Agenda Item 3 222 E. Onwentsia Road

STAFF REPORT AND RECOMMENDATION

SUBJECT: 222 E. Onwentsia Road Continued Consideration - Two Story Addition and

W
 E
 S
 T
 E
 L
 E
 V
 A
 T
 I
 O
 N

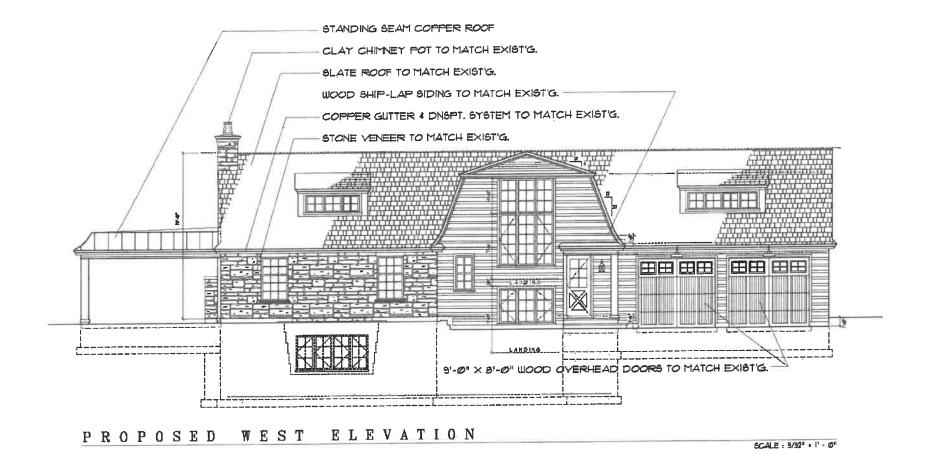
The previous plans reflected openings stacked between the first and second floors on the west elevation of the addition that did not appear consistent with the rhythm of solids to voids on the existing home and in response to the Commission's direction during the previous meeting, the petitioner revised the plans to eliminate the stacked openings.

- 7. Refine the west elevation of the addition to present openings that follow the rhythm of the solids and voids on the existing house. We have revised the floor plan to follow the rhythm of solid and voids on the existing house. We moved the garage to the west to "open up" the SW exposure. This will increase the lawn and garden areas at the front of the house and preserve the front gambrel priority. Window and door openings at south and west elevations will follow details and proportions present on the existing house.

This standard was generally met at initial submittal. The west elevation has been revised and is consistent with rhythms of solids to voids. The south elevation is consistent as well. We have reduced the massing/size of the upper stair window to be in proportion to the existing house. This standard has been addressed.
